### **ADDENDUM 3**

June 8, 2026

ADDENDUM NUMBER 3 to CONTRACT DOCUMENTS for

#### **A NEW PUBLIC WORK FACILITY**

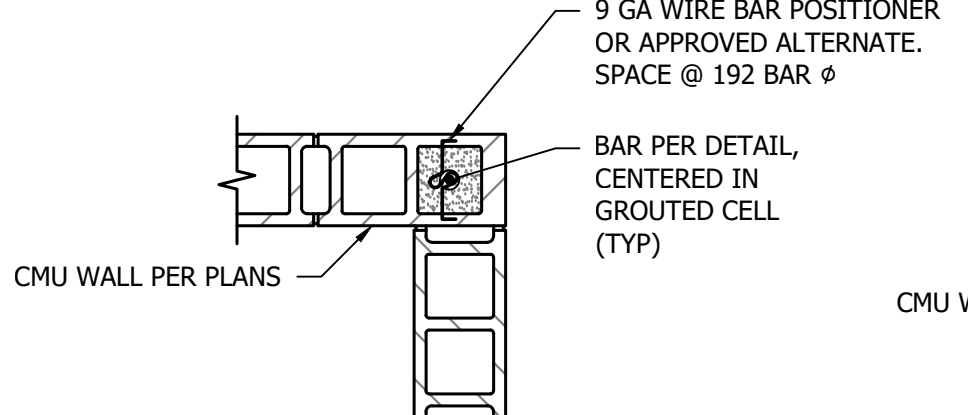
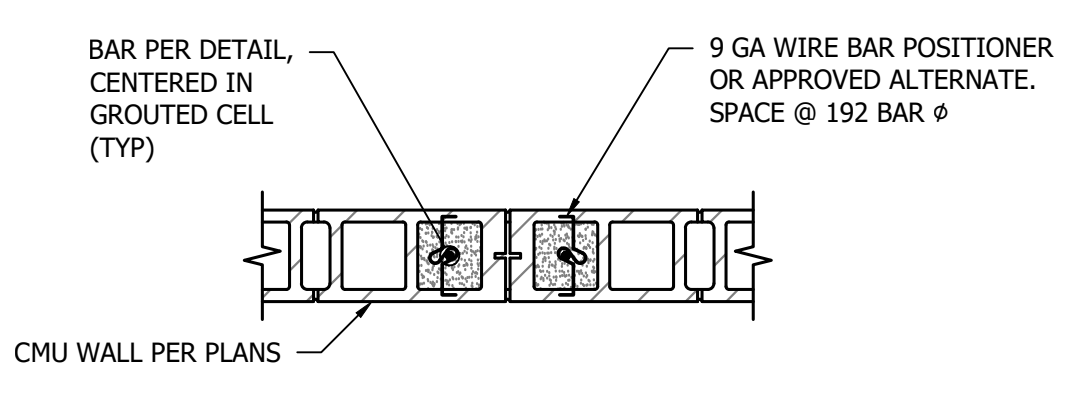
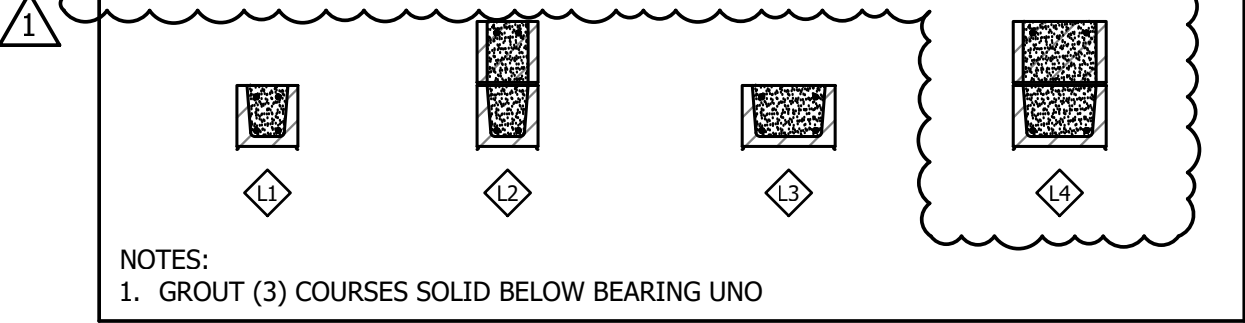
THICKENED SLAB  
DETAIL DELETED
